PLANNING & ZONING BOARD AGENDA

Wednesday, September 10, 2025

**PLANNING & ZONING BOARD
AGENDA ITEM 6C**

The applicant, TJB Homes, Inc, submitted a land use application to amend the preliminary plat application for Lake Amelia Woods. The applicant proposes to revise the grading plan related to the existing four (4) lot rural subdivision. Since the grading plan is part of the preliminary plat application, any significant change to the grading plan requires a formal preliminary plat amendment. No additional lots are being created.

TITLE:
SITE GRADING - LOT 3
LAKE AMELIA WOODS
LINO LAKES, MN

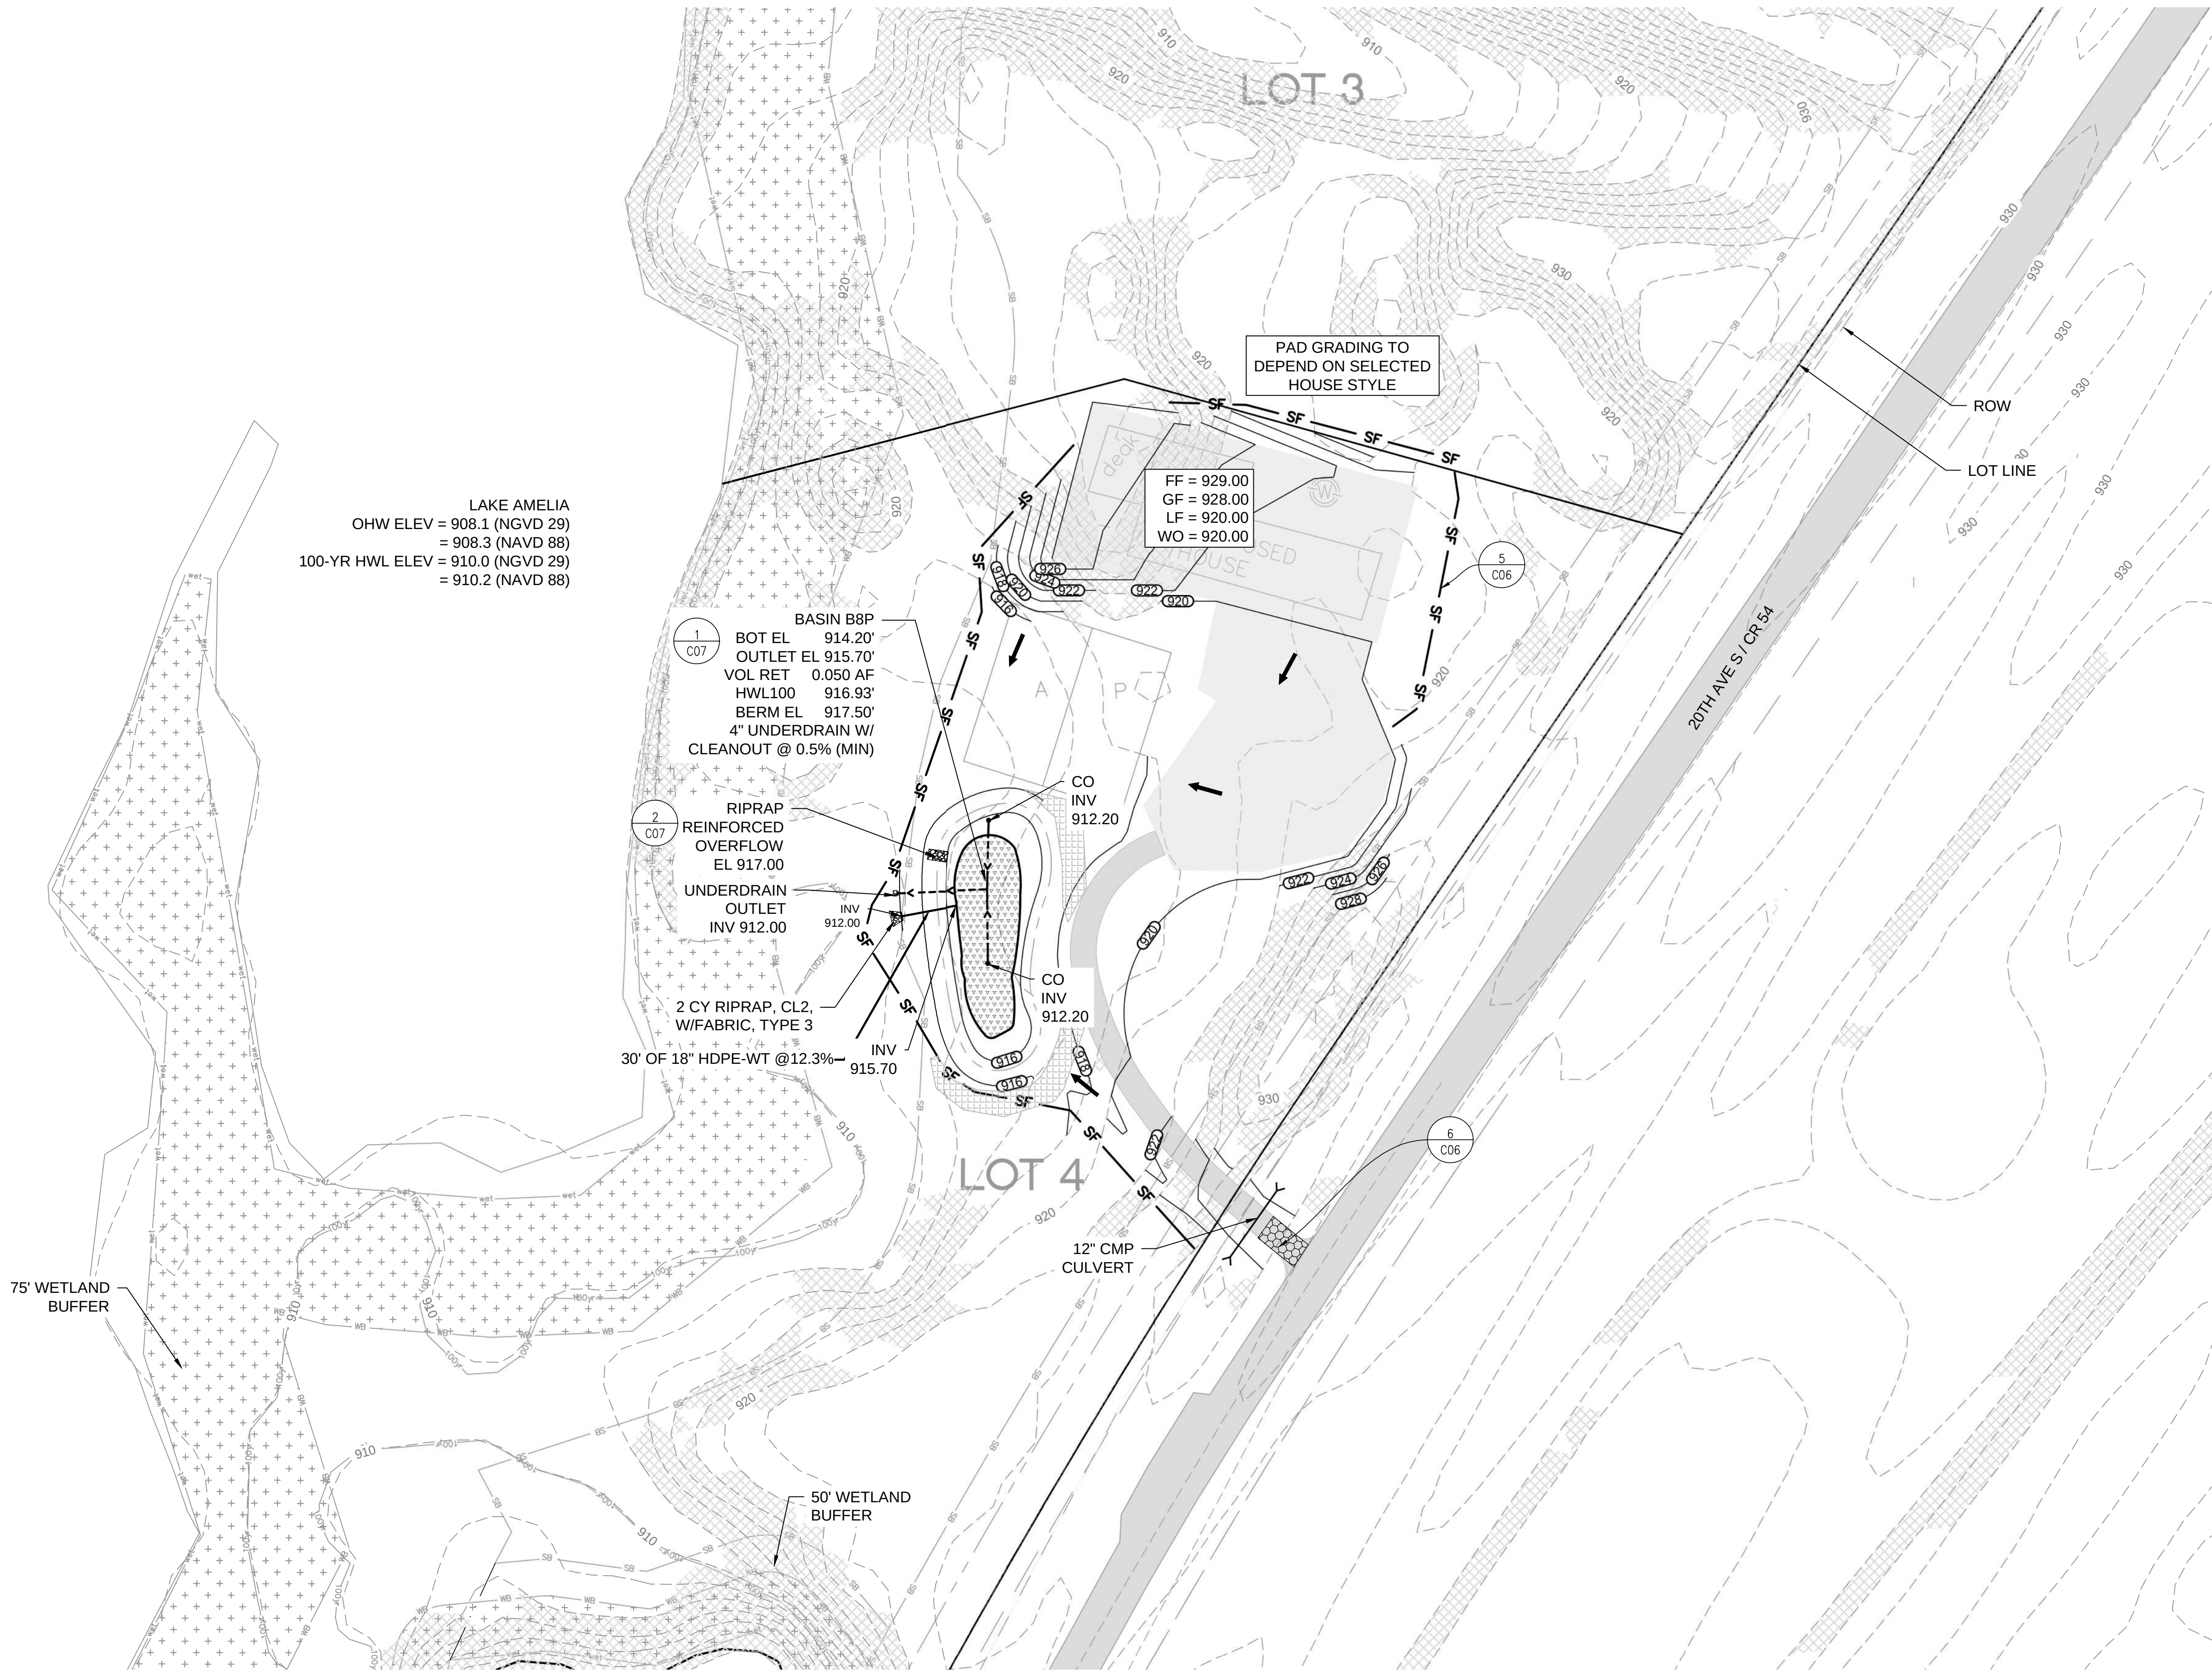
~~7. Provide calculations to confirm the adequacy of the sizing for the proposed culverts. The culvert shown on sheet C02 velocity exceeds 6 fps. Design outlets to the wetlands to achieve an outlet velocity less than 6 fps.~~

~~The proposed culverts, including the noted culvert on sheet C02, have been modified to reduce velocity to less than 6 fps for the 100-year storm flow. HydroCAD results for proposed culverts are provided in the following table:~~
